# **BOARD OF ZONING APPEALS**

**Z16-11**

**795 Miner Drive**

**Subject:** Variance request from Section 1147.12 (B) of the Planning and Zoning Code allow two ground signs to be 32 feet in area and 7.5 feet high which exceeds the code requirements of 20 square feet in area and 6 feet high.

# Brilliant Electric Sign Co., Ltd.

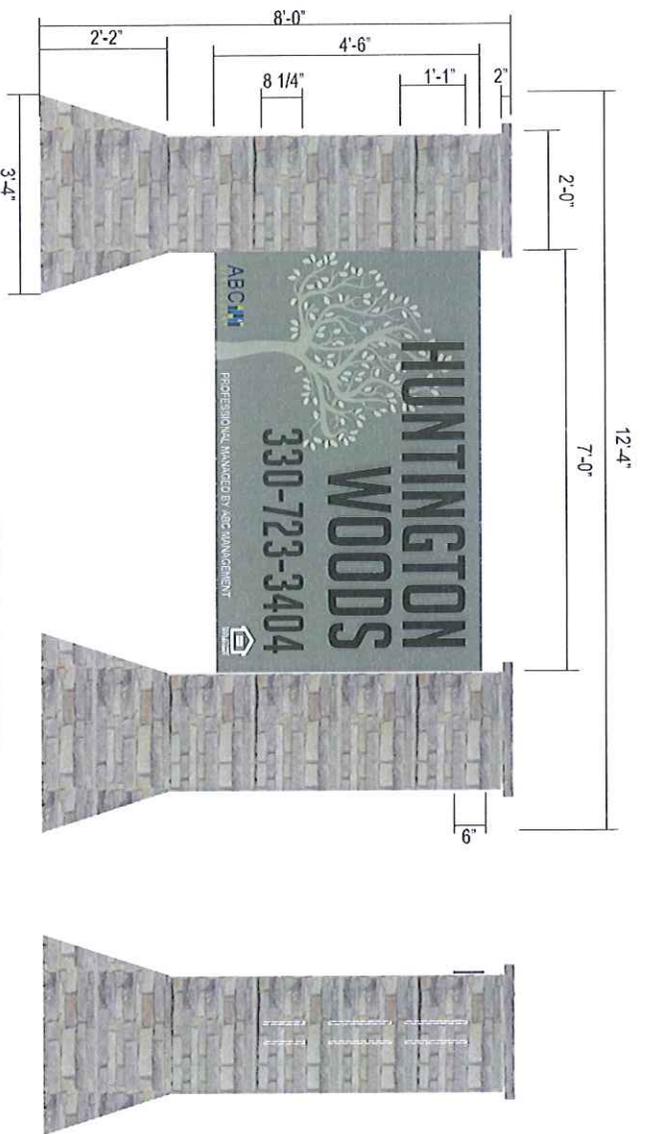
Due to the size of the site, the larger signs may appear appropriate in scale. The location of the State Road entrance sign is proposed at 15 feet off of the right of way and the Miner Drive entrance sign is proposed at 11 feet off of the right of way. The proposed locations exceed the minimum required setbacks by more than 115%. The increased setbacks may help the signs to appear more appropriate contextually with the site.

The variance sought may not be the minimum necessary for the ground signs. The brick posts could be reduced so that the sign meets the code height requirements.
